# Nuclear Medicine Associates, Inc.

Patricia C. Vacca  
Material Licensing Branch  
Division of Fuel Cycle and  
Material Safety  
U.S. Nuclear Regulatory Commission  
Washington, D.C. 20555

Re: Control #16016  
'84 MAY 11 P3:30

This letter is in response to your request for further information regarding the new license application for Ohio Isotopes, Inc. The items in this response are intended to correspond numerically to the questions in your letter dated March 1, 1984.

Enclosure 4,a  
Facilities and Equipment  
Diagram

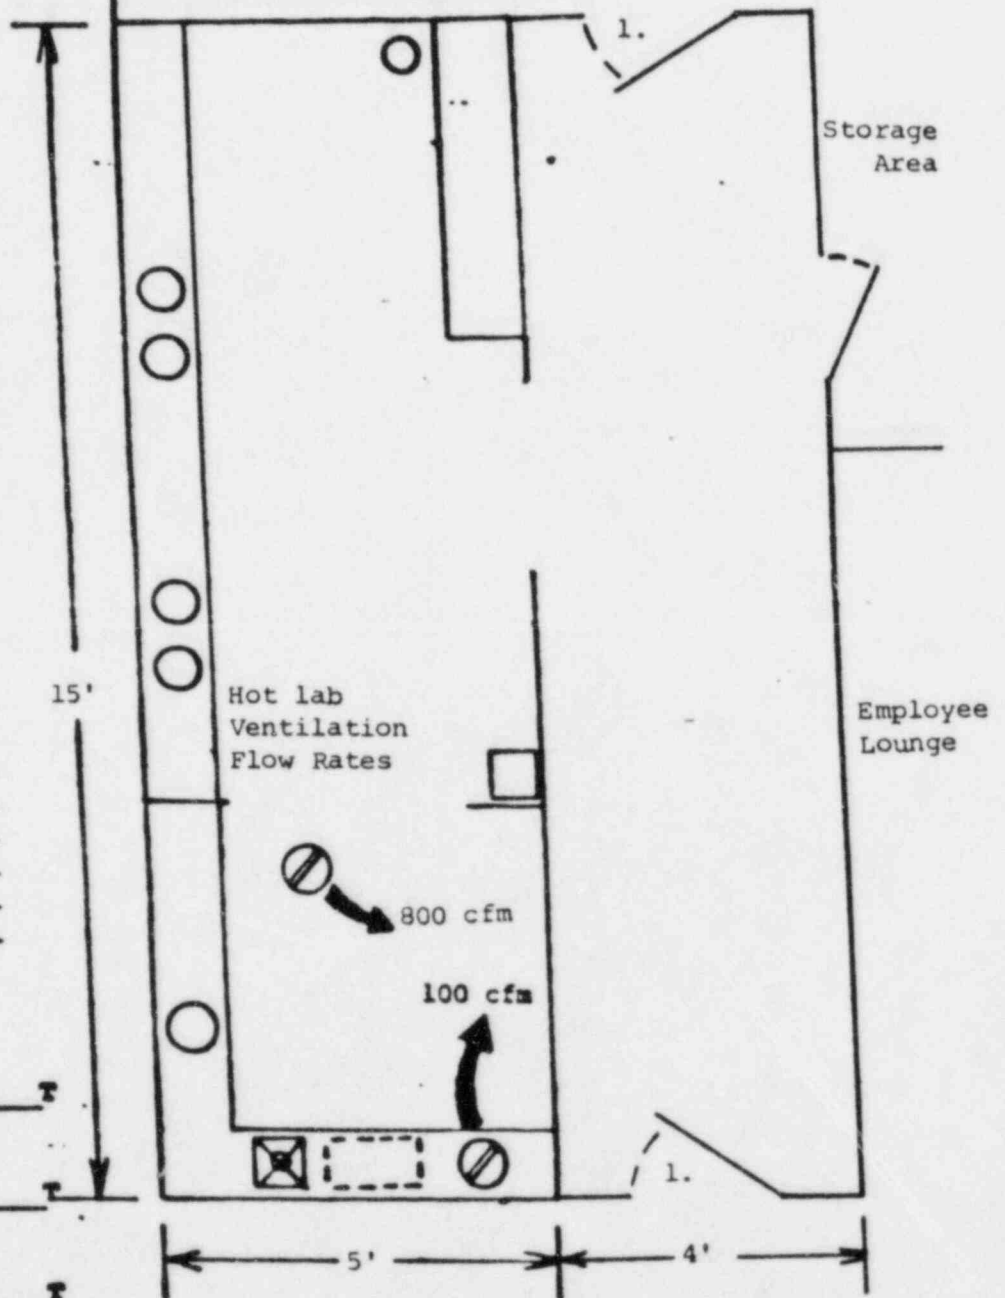
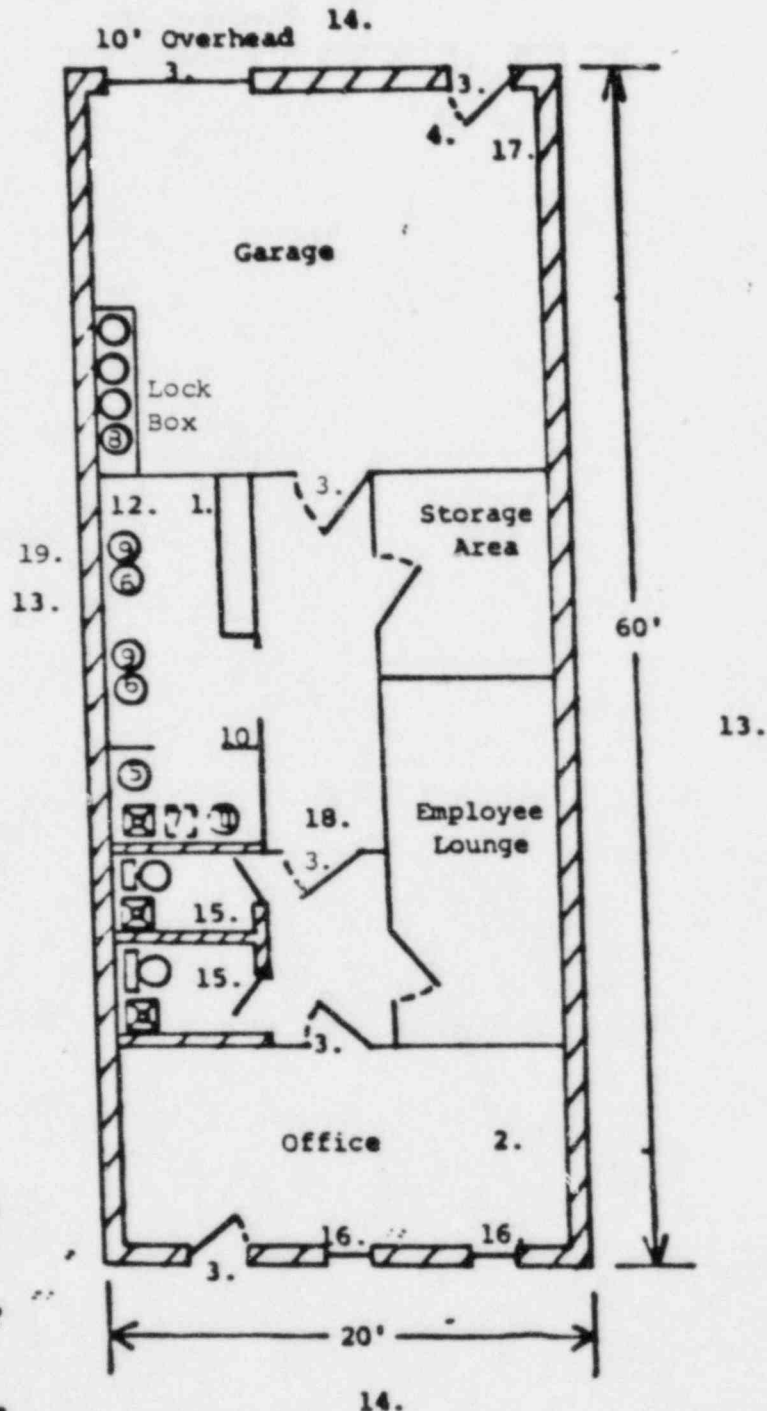
6. A. Revised drawings, Enclosure #4, a & b have been provided to show the new location of the exhaust vent and a change in placement of a door leading to the hot lab area. To provide equivalent limited access, a lockable door will be at each end of the hallway connected to the hot lab. The Xenon program is resubmitted in it's entirety due to restricted area volume changes and a request for a possession limit of 1500 mCi of Xenon-133 instead of original 2 Curies.
